# MERER RUISER CERTIFIED STERN DRIVES

## SERVICE BULLETIN

Number: 75-4

Date : 5/9/75

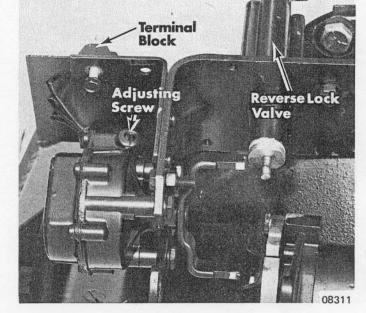
Some MerCruiser 255TR and 280TRS shift actuator motors do not have proper end play adjustment, which could cause shift actuator switch assembly life to be reduced.

Inspect all 255II-TR and 280II-TRS units with Serial No. 4175500 thru 4176704 during the 20-hour check or when performing normal maintenance.

- 1. Remove shift motor cover.
- 2. Adjusting screw (Figure 1) must be below or flush with housing. If screw protrudes above housing, use the following adjusting procedures.

- 1. Turn adjusting screw in until tight, then back off screw ½-turn. (Figure 1)
- 2. Coat adjusting screw with Liquid Neoprene (C-92-25711) to prevent adjusting screw from moving.
- 3. Install shift motor cover.
